PRELIMINARY PLAT
SUBDIVISION REPORT

S/D NO. 73-20 Name MARINA LAKE FIFTH ADDITION
Date Application Rec'd. 2-15-73 Preliminary Approval _____
Scheduled S/D Meeting 3-1-73

Subject: S/D 73-21 - Preliminary
Plat of MARINA LAKES FIFTH ADDITION

Re: S/D 81-12 - Preliminary plat of Marina Lake Fifth Addition

REQUEST TO ACCEPT
EASEMENT TRANSFER-
RING MARINA LAKES
COLLECTION SYSTEM
TO THE CITY

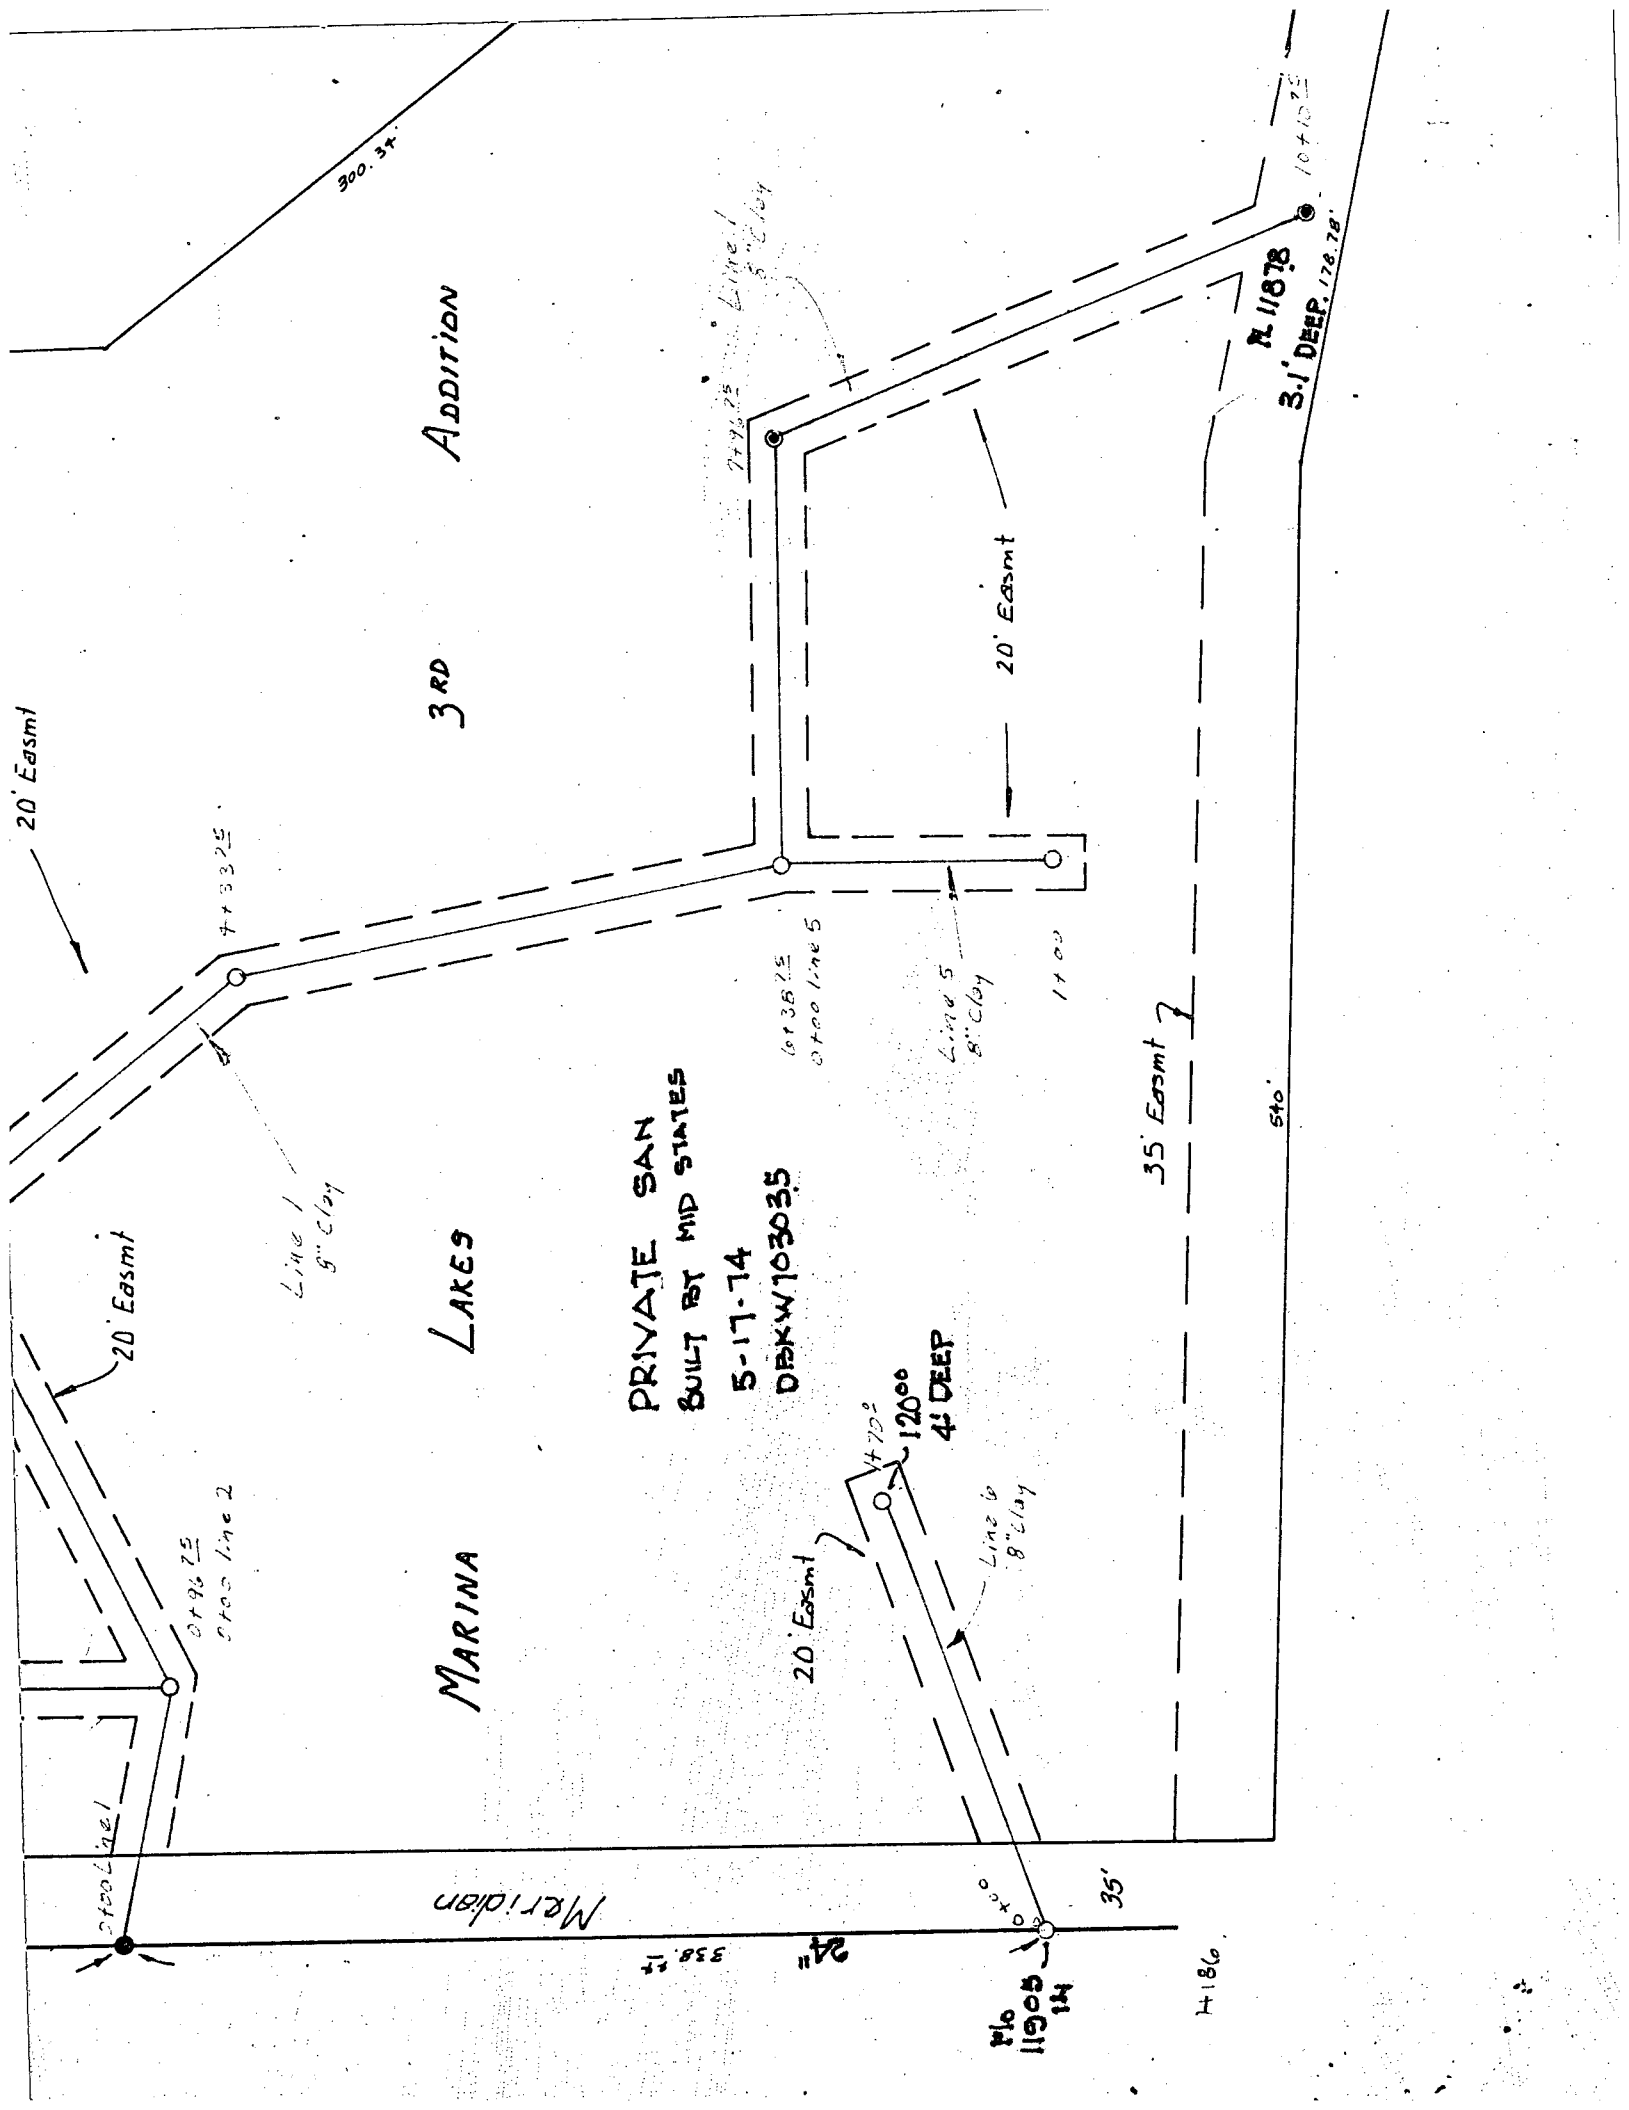
The City has been requested to accept the Marina Lakes sanitary sewer collection system for City maintenance. At the time Marina Lakes was developed, it was served by a private lateral and lift station constructed to City specifications and inspected by the City. Marina Lakes built the collection system as a private concern in order to expedite construction.

The City Manager recommended acceptance of the easement subject to:

1. Right of ingress and egress from Amidon Avenue for the maintenance and operation of the lift station.
2. Payment in the amount of \$1,015.20 for the cost of televising and cleaning the line.
3. Correct connections at stations 12+94, 12+36 and 11+80.
4. Repair breaks at stations 9+37 and 7+41.
5. Repair joint at station 4+44.
6. Cut back invert in manholes at stations 5+65 and 8+84.
7. Change electrical service to remove from shopping center and locate near lift station with KG&E disconnect panel and new line from lift station.
8. Change alarm system to be compatible with City's present system.
9. Filing with the Register of Deeds.
